SYDNEY NORTH PLANNING PANEL 2017SNH074

Response by St Vincent's Health Australia to North Sydney Council's Assessment Report

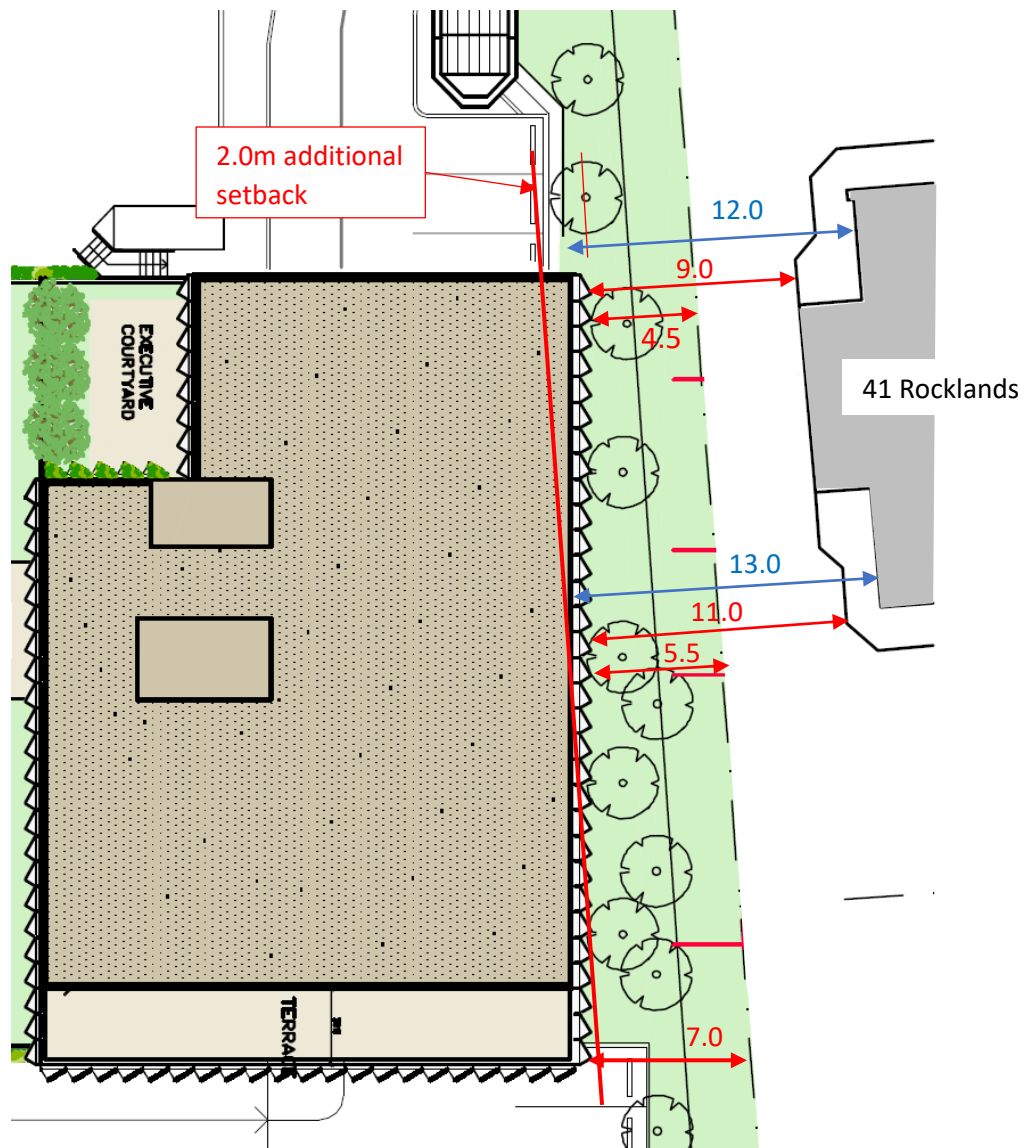
ii. The northern (Executive) building being setback an additional 2m setback from the northern boundary;

1. The northern Executive building as proposed complies with the required setback.
2. Narrowing the building by 2.0 m is unacceptable as it would result in a net loss to the gross floor area of 130m² which would compromise the specialist consulting rooms necessary for optimal Palliative Care
3. Sliding the building 2.0 m to the South is also unacceptable as it would result in a loss of 70m² of landscaping to the Palliative Care garden.
4. Finding spiritual solace in a natural setting is a critical part of palliative care and we would vigorously resist any attempt to reduce the precious gardens. We concur with the NSCAR when it states (p24):

'If the consulting building (top adjacent to boundary) was moved completely over the existing multi level carpark, there would no increase in site cover.

*The result would be a **significantly decreased landscaped courtyard and no benefit other than increased setback to 41 Rocklands Road.** The benefit of the landscaped courtyard is to provide a peaceful outlook, solar access and a meeting place for those patients in palliative care.'*

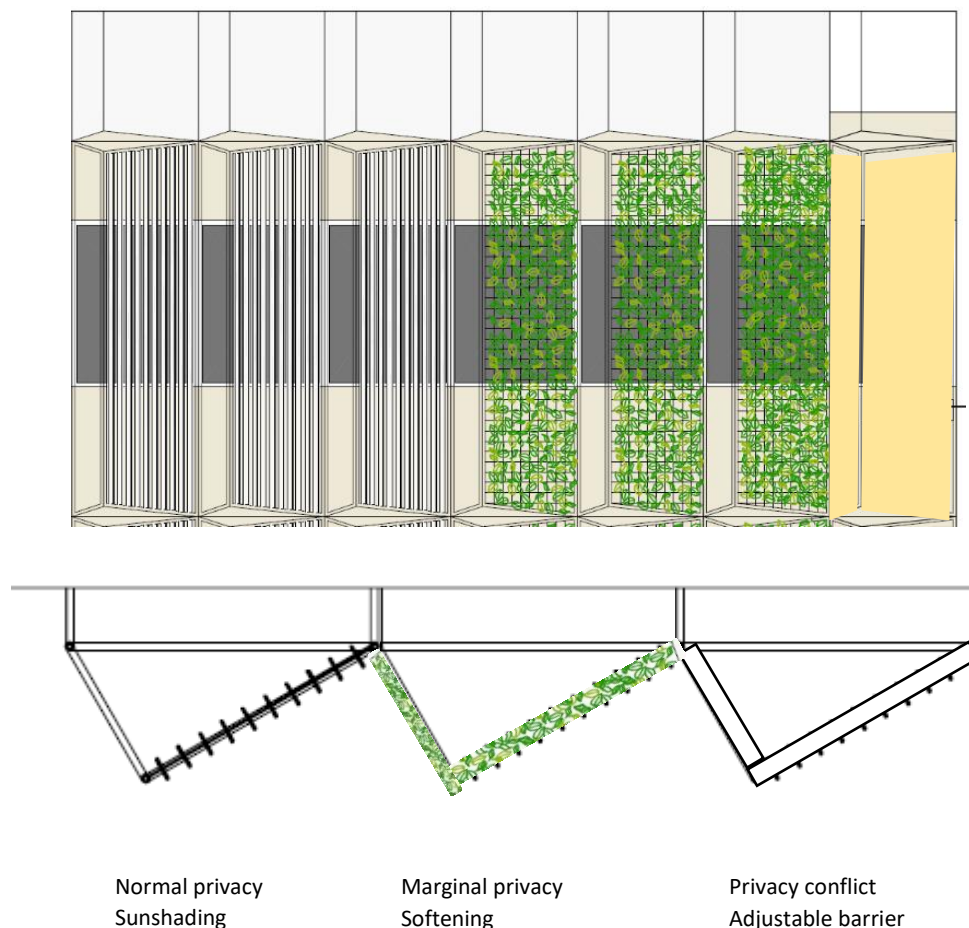
iii. Additional privacy screening being provided to all windows opposite apartment buildings and along the terrace edges;

2. In hospitals privacy is paramount and essential to generating a strong feeling of security to support patients when they are at their most vulnerable. Over the years the Mater has trialled many systems to ensure absolute security without losing the benefits of natural light and external views. Currently the system used in the Hospital is a combination of tinted glass, variable opacity blinds and louvred shutters which allows the balance between privacy and external views to be varied to suit individual needs.

3. In addition the buildings will be clad in an external modular framing system which will permit the insertion of panels ranging from aluminium louvres to living plants of varying opacities. Where a potential privacy conflict occurs between the proposed buildings and neighbouring residences then the panels at that point will be detailed to be the most opaque, with the option of deleting a window completely if the conflict is critical.

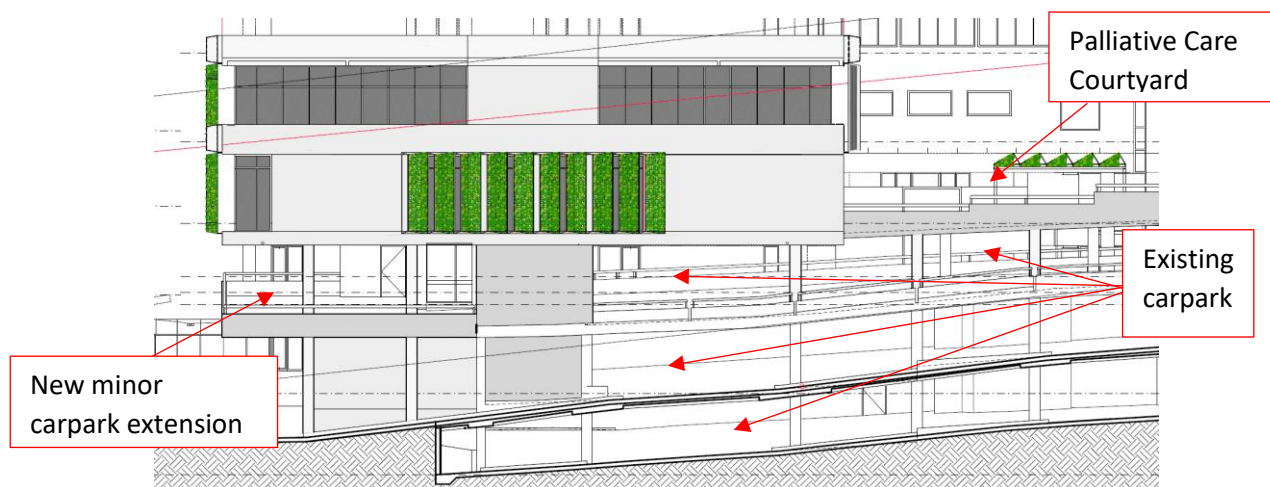
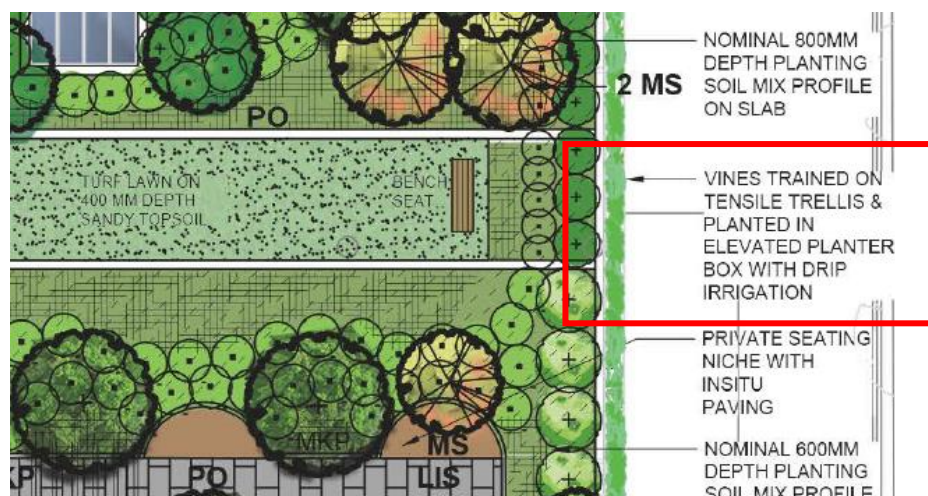
iv. Provision of screening (planting and/or architectural panels) on the eastern edge of the carpark below the courtyard;

1. This condition is mystifying as the carpark is existing and currently does not have any screening, nor are there any plans to screen it other than by edge softening (see 4). Also the existing boundary fence and trees to the driveway currently screen it from the Hazelbank properties, neither of which have prime living areas overlooking it (20 Hazelbank has no windows).

2. It is intended to slightly extend the car park, but by only 10.0m and **under** the Palliative Care building but this is opposite the adjacent property of 1 Gillies street and at the same level as the existing carpark.

3. To provide edge screens to the existing carpark when it is covered by the new courtyard would impact on its performance as a naturally ventilated carpark and would require mechanical ventilation and hence extra cost.

4. It is however proposed to provide planting boxes with trailing vines, along the top edge of the new landscaped deck to soften the new structure.
